**Mueller Property Holdings, LLC**  
**Birmingham, Alabama**  
**EPA I.D. Number ALD 004 017 901**

**FACT SHEET**

A draft modification of the Alabama Hazardous Waste Management and Minimization Act (AHWMMA) permit has been prepared for the Mueller Property Holdings, LLC facility. This hazardous waste facility is located in Birmingham, Alabama. This fact sheet has been prepared to briefly advise the public of the principal permitting, legal and policy issues of the draft permit.

### VI. SUMMARY OF PROPOSED MODIFICATIONS

**FIGURE 1: PROPOSED MONITORING WELLS FOR REMOVAL**

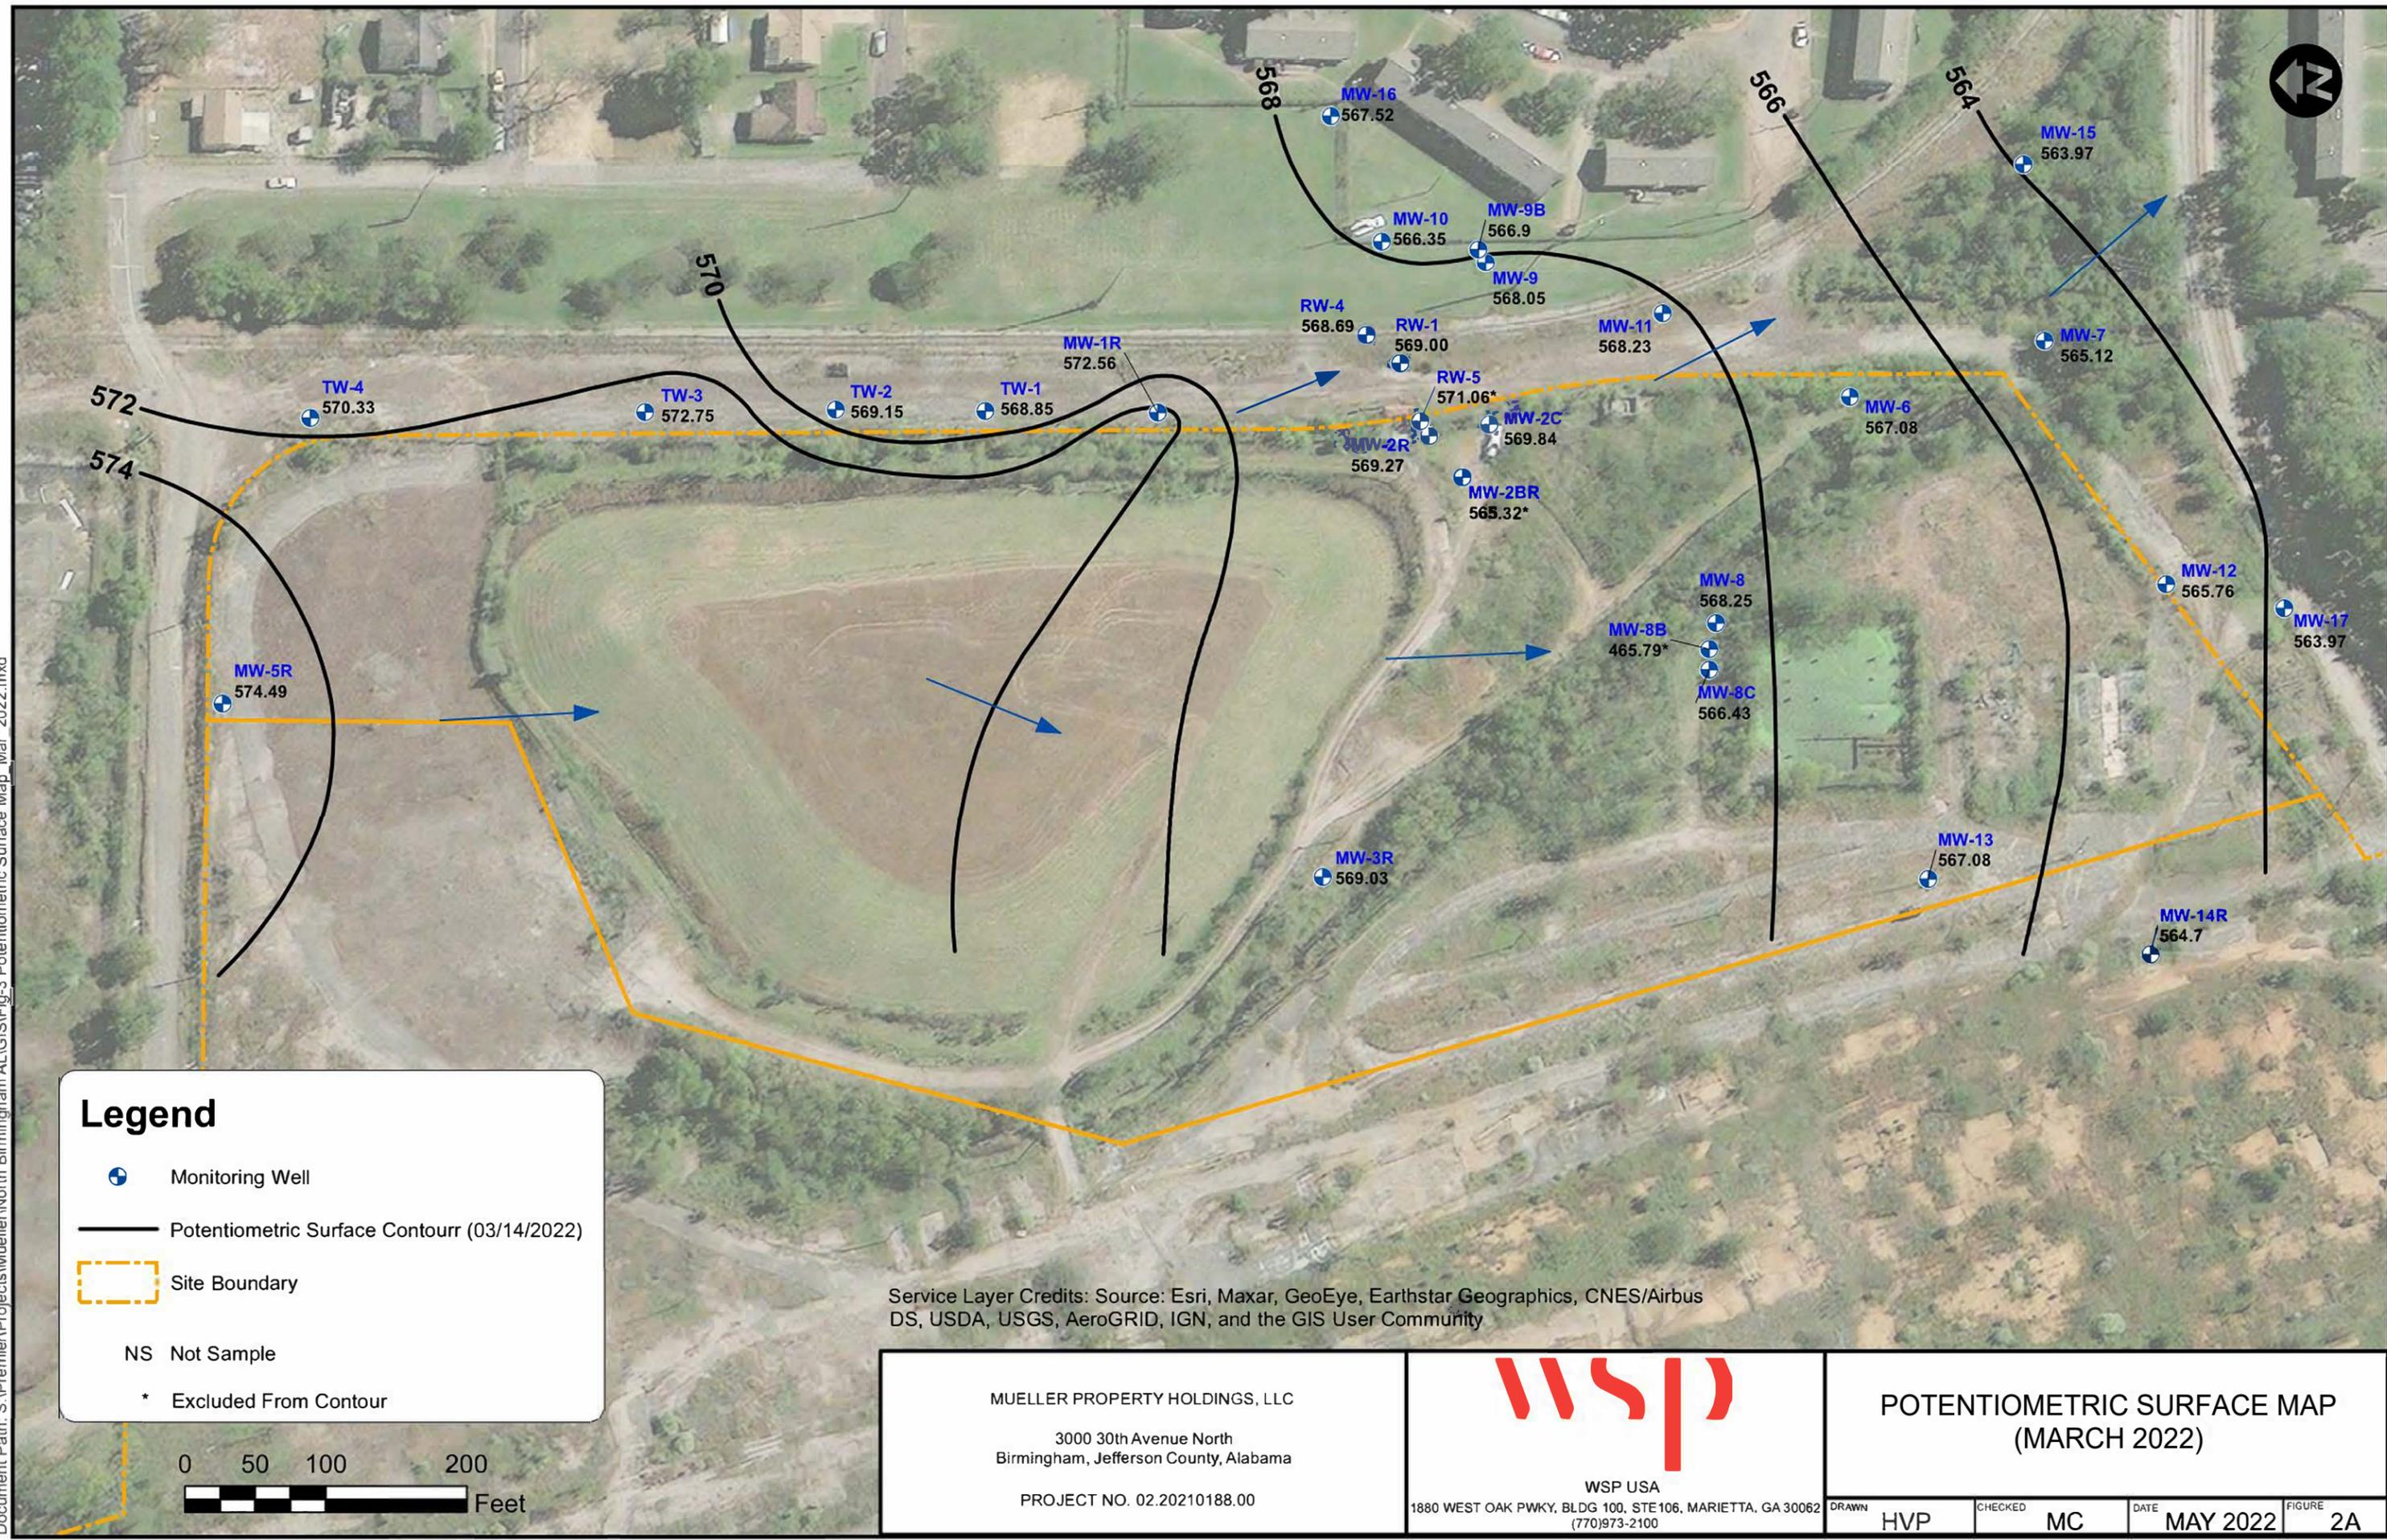
**Figure 1** depicts the monitoring wells proposed for abandonment which include wells MW-7, MW-8B, MW-10, MW-11, MW-14R, MW-17, and TW-1 through TW-4.

FIGURE
D-1

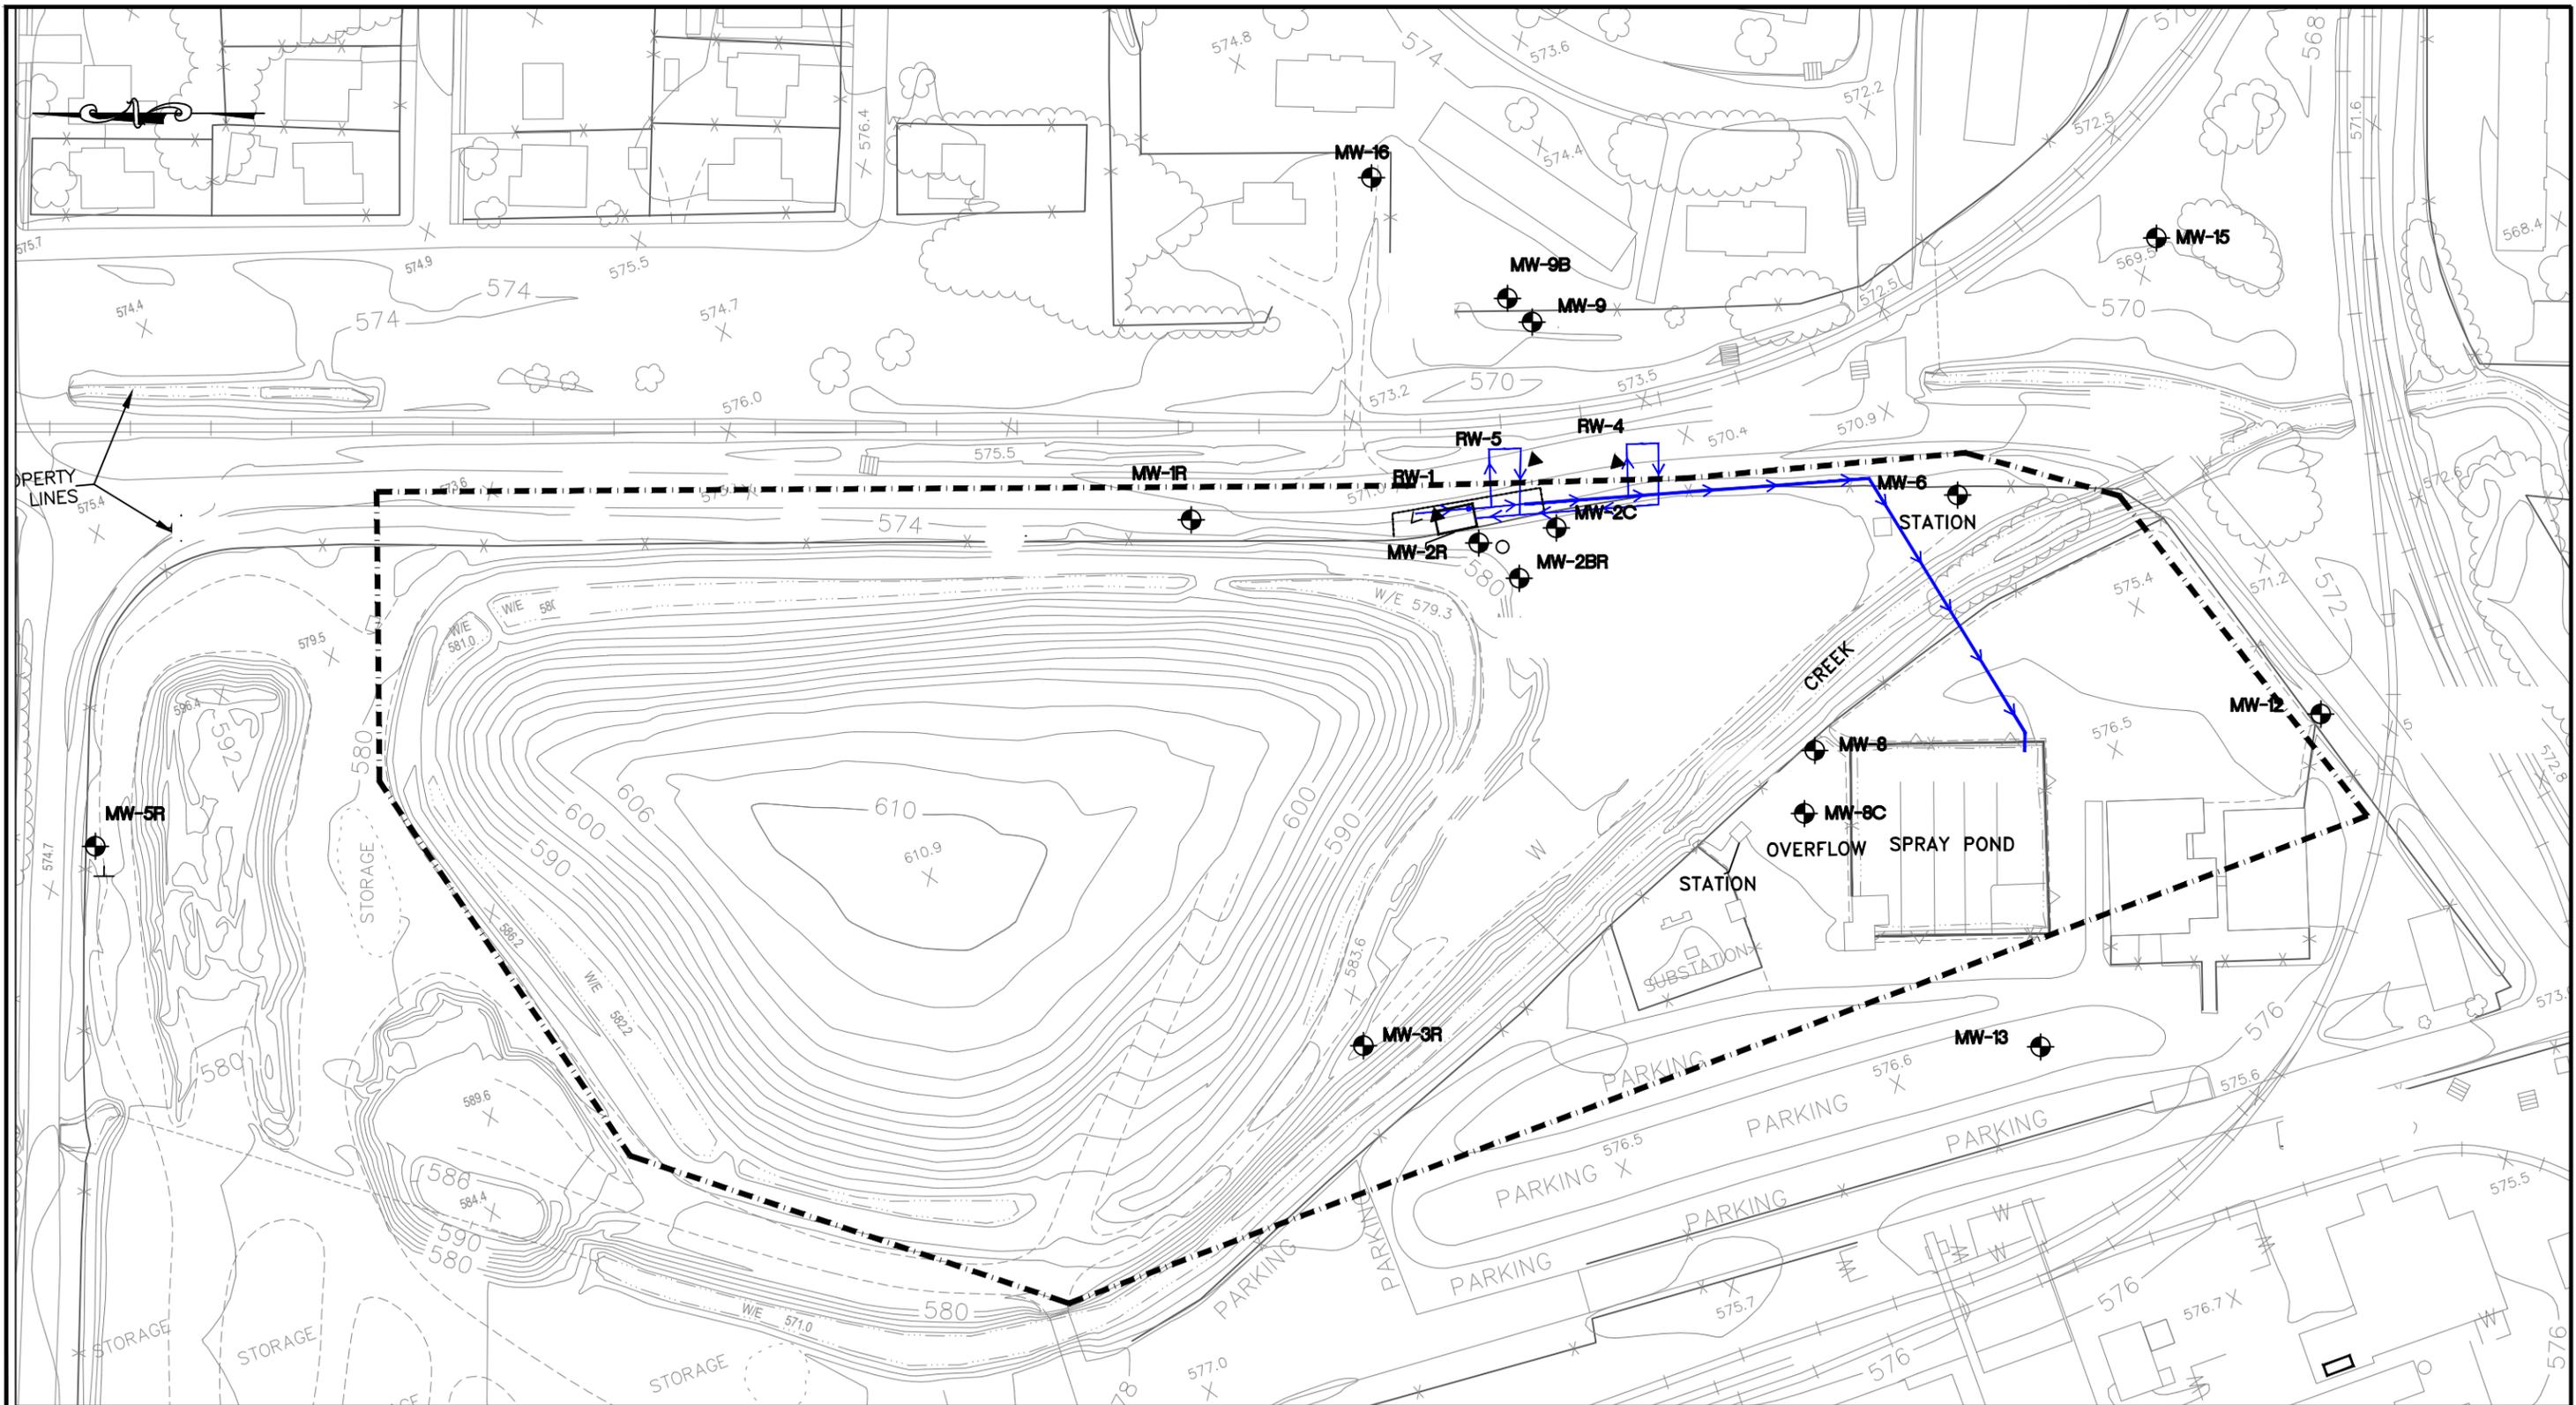
4	Section III.B.1.a., Page 1	Reference Figure D-1 of the Revised Corrective Action Program (included as Appendix D of this Permit Modification Request).	Required to reflect changes to the groundwater monitoring program.
5	Section III.B.1.a.i, Page 1	Change reference from Appendix E to Appendix D.	Change reference from Appendix E to Appendix D to be consistent with Permit Application.
6	Section III.B.1.a.ii, Page 1	Delete/abandon certain monitoring wells following ADEM approval of the Permit modification.	A monitoring well abandonment plan is included as Attachment 2 of the Permit Modification (See item 13 below).
7	Section III.B.1.c, Page 2	Change reference from Appendix E to Appendix D.	Change reference from Appendix E to Appendix D to be consistent with Permit Application.
8	Section III.B.5.a, Page 4	Remove reference to Appendix F and cite Appendix E (SAP).	The Permit should reference Appendix E in this section. Appendix F was incorrectly cited in this section.
